STATE OF MICHIGAN
BEFORE THE MICHIGAN PUBLIC SERVICE COMMISSION

Application of Enbridge Energy, Limited)	
Partnership for the Authority to Replace and)	
Relocate the Segment of Line 5 Crossing the Straits)	Case No. U-20763
of Mackinac into a Tunnel Beneath the Straits of)	
Mackinac, if Approval is Required Pursuant to)	
1929 PA 16; MCL 483.1 et seq. and Rule 447)	
of the Michigan Public Service Commission's)	
Rule of Practice and Procedure, R 792.10447)	
_____)

REOPENED RECORD DIRECT TESTIMONY OF
TRAVIS WARNER
MICHIGAN PUBLIC SERVICE COMMISSION

**NINTH DISCOVERY REQUESTS TO ENBRIDGE ENERGY, LIMITED PARTNERSHIP BY
MICHIGAN PUBLIC SERVICE COMMISSION STAFF (MPSC)**

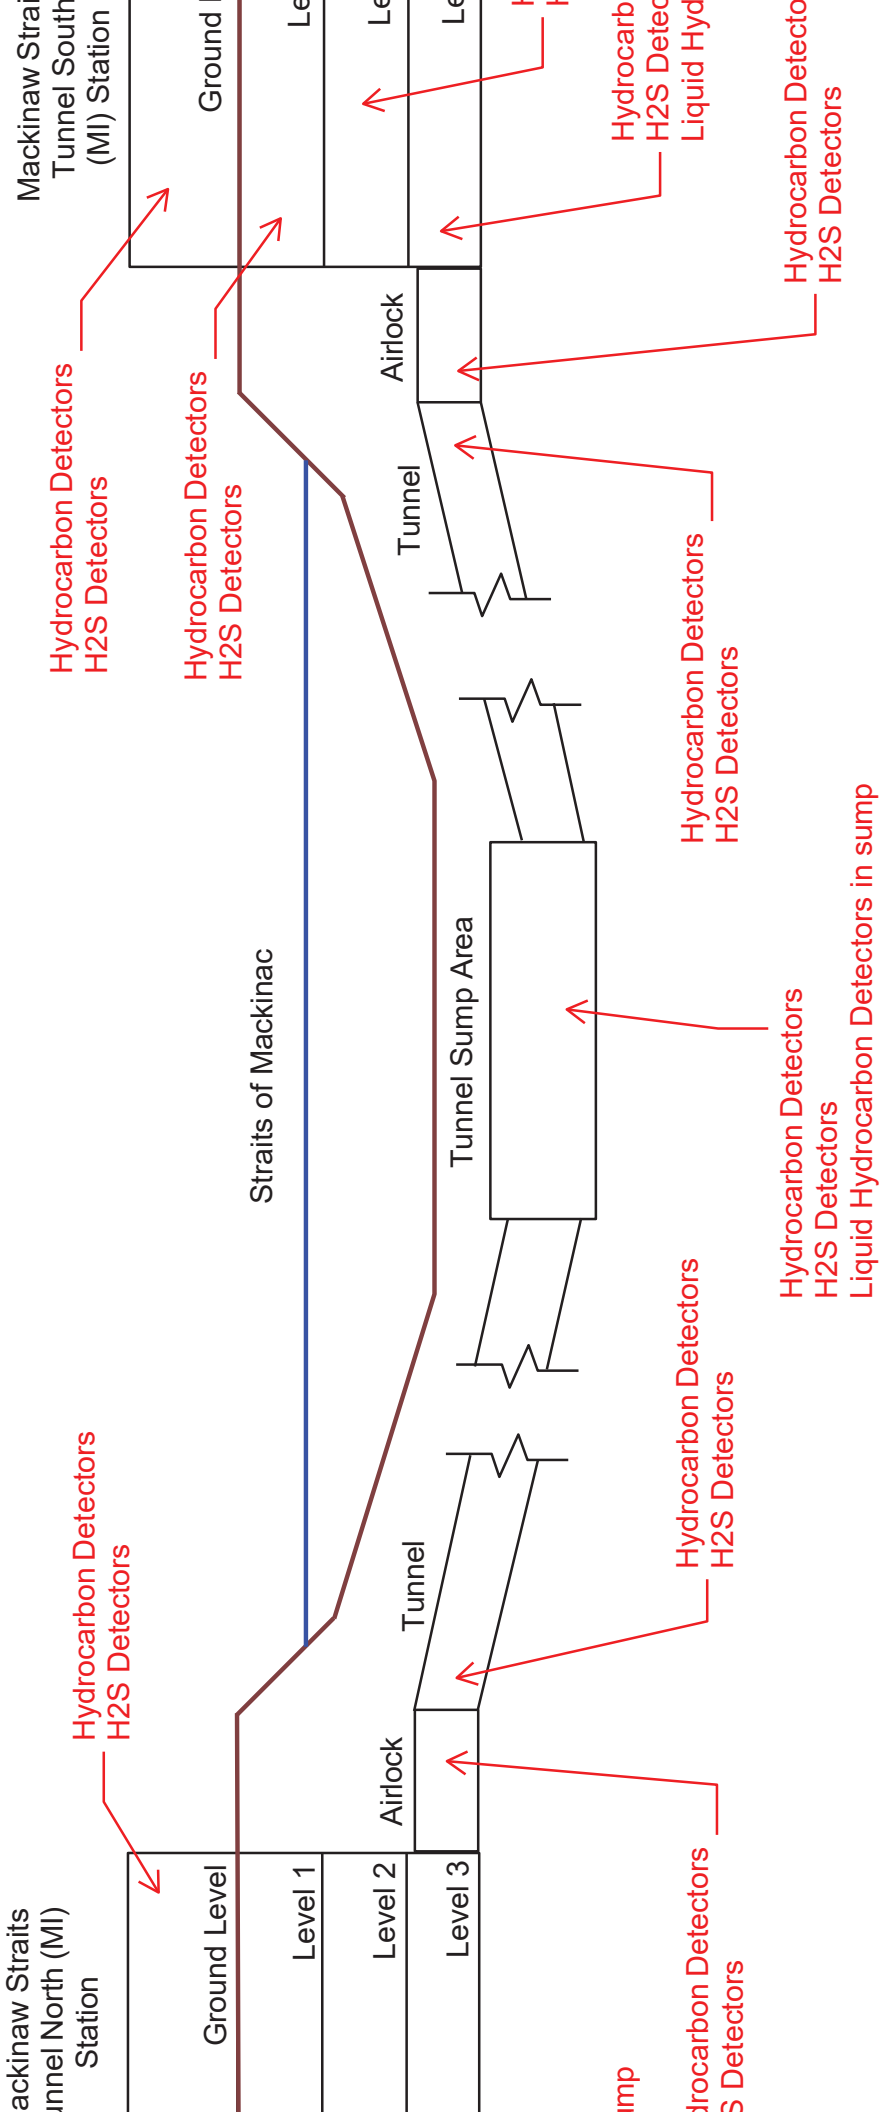
Request No.	
10(2)	Reference: Response 2 of Appendix B to Exhibit A-29
Request:	Referring to Response 2 of Appendix B to Exhibit A-29: a. Please provide the rationale for proposing to not locate any gas detectors between the “north Straits end of Tunnel (near Airlock)” and the “Tunnel Sump,” and between the “Tunnel Sump” and the Mackinaw Station end of Tunnel (near Airlock)” b. Please provide a visual depiction (schematic, diagram, drawing, etc.) of the profile of the tunnel and shafts showing the general locations of the gas detectors, liquid hydrocarbon detectors, sump, airlocks, and any other relevant components.

Response:	a. Consistent with Enbridge's presentation to this point in in this case, the Project adopted an approach and philosophy to minimize the need for tunnel entry by people since this was considered to be the primary driver of risks to life safety and asset integrity. Therefore, the tunnel is confined space with permit required for entry. See January 14, 2022, Surrebutal Testimony of Aaron Dennis at page 4, lines 7-13 (Vol. 8 Hr'g Transcript at 801, lines 7-13); see also Exhibit A-29 at page 49 of 52 of Appendix B to "Enbridge Line 5 Great Lakes Tunnel Project: Probability of Failure Analysis," filed October 21, 2022 with Direct Testimony of J. Godfrey. Minimizing the number of instruments in the tunnel, including gas detectors, is designed to align with this approach. The detectors installed in proximity to the airlock and near airlock (as identified in the attached schematic) provide adequate detection to detect a release. The other means of leak detection will provide additional layers of protection. b. See attached schematic.
